# 1992 Corvette ZR-1: Service Bulletin: Lack of Wide Open Throttle Engine Underpower

**Subject:** LACK OF WOT-LOW ENGINE POWER REVISED CABLE ADJUSTMENT PROC.

**Model and Year:** 1992 CORVETTE ZR-1 WITH 5.7L ENGINE AND MANUAL TRANSMISSION

**Bulletin Number:** 92-214A-7B - (07/01/1992)

THROTTLE BODY AND ACCELERATOR PEDAL CABLE ADJUSTER

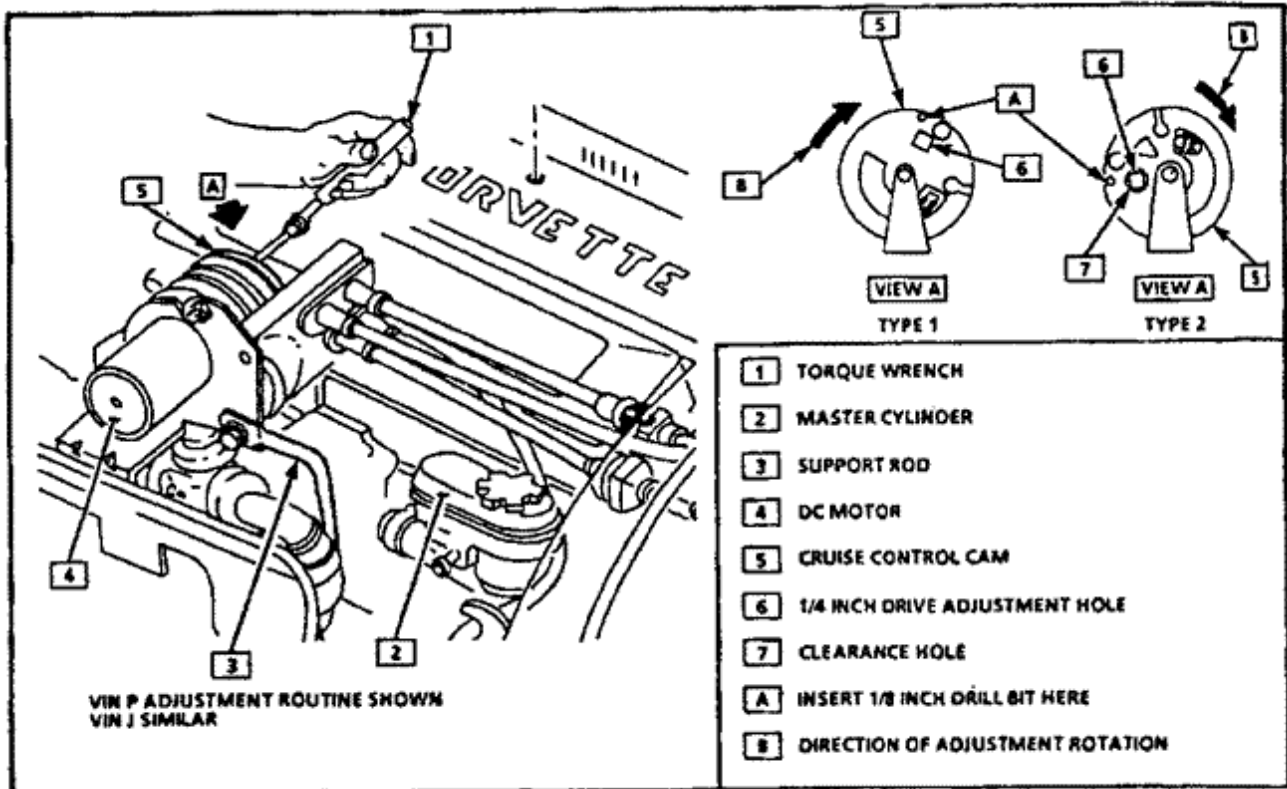
1. Remove adjuster cam assembly splash cover, foam shield, and cable cam cover.
2. Disconnect cruise control cable from the cruise control servo.
3. Depress reset button on the throttle control cable and fully extend cable sheaths (see figure).
4. Insert a 1/8 inch drill bit into adjuster assembly alignment hole (see figure, item A).

5. Insert a torque wrench with a 1/4 inch drive extension into square hole on the cruise control cam (type 1) or through the cruise control cam into the accelerator cam (type 2) (see figure, item 6).
6. Turn the torque wrench clockwise until obtaining a torque of 4 N.m (35 lbs. in.). During adjustment, several clicks of the adjuster should be heard. If not, repeat step 3.
7. Remove the torque wrench AND drill bit.

• ALWAYS MAKE SURE CABLE SHEATHS ARE AT THEIR FULLY EXTENDED POSITION BEFORE PERFORMING ADJUSTMENT PROCEDURE
